S E R V I C E N O T E

**Agilent E5100A/B Network Analyzer**

**ADMINISTRATIVE INFORMATION**

**Figure 1. AC Inlet Connector**

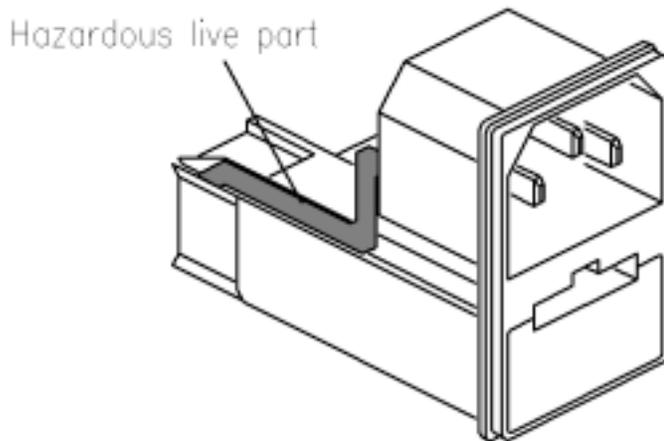
The AC inlet (P/N 1252-6951) has the potential to slip out of the instrument's rear panel slot if the AC power cord is forcefully pulled in a diagonal direction. When this happens, an exposed connection on the AC inlet module may touch the rear panel of the instrument and cause an electrical short if the AC power cord is still connected to the AC power outlet. See Figure 1.

In the worst case, there is also a possibility of an electric shock hazard to the user if the user completes a circuit between the instrument panel and another grounded connection while the AC power cord is still connected to the AC power outlet.

- Remove the AC power cable from the AC power outlet and the product.
- Remove the top, bottom, and side covers.
- Seal the hot line terminal on the AC inlet with silicon paste (P/N 5183-4112).
- Reinforce the connection between the AC inlet and the rear panel with silicon paste.
- Perform Self Test to verify instrument operation.
